Proposal #41: 9925-00-70, WISC 2025178
Mellen - USH 2
STH 13 to Ashland/Iron County line
STH 169
Ashland County

9925-00-71, WISC 2025179
Mellen - USH 2
Bad River Bridge B-02-0026
STH 169
Ashland County

This is Addendum No. 02, which provides for the following:

ADDENDUM NO. 2
9925-00-70
December 18, 2024

Addendum No. 02
ID 9925-00-70
Added Sheet 43A
December 19, 2024

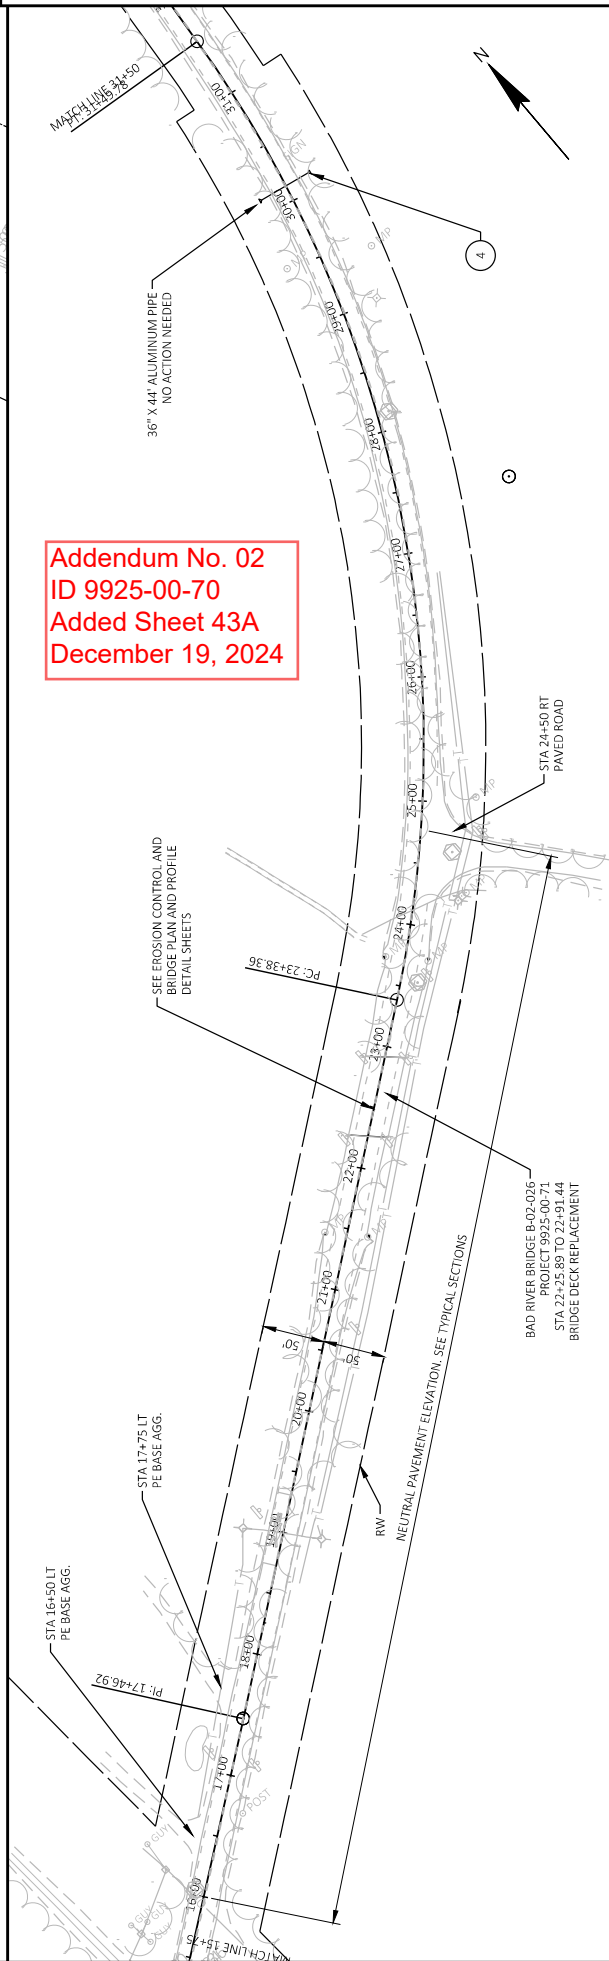
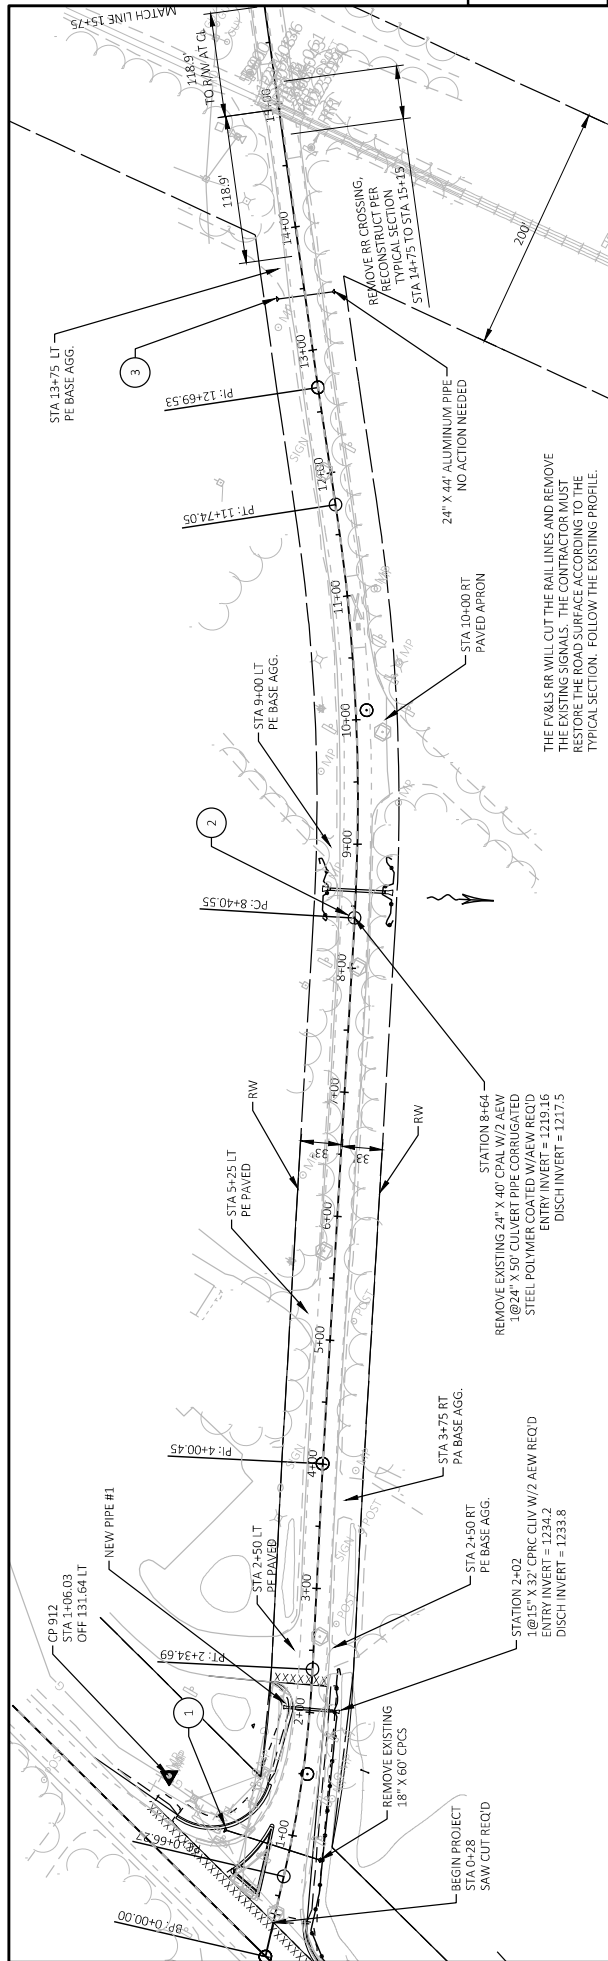
Added Plan Sheets	
Plan Sheet	Plan Sheet Title (brief description of why sheet was added)
43A	Added missing plan sheet for STA 0+28 – 32+00
74A	Added Standard Detail Drawing 13B01-11a "Pavement Details for Railroad Approach"
74B	Added Standard Detail Drawing 13B01-11b "Typical Sections for Railway Approach"
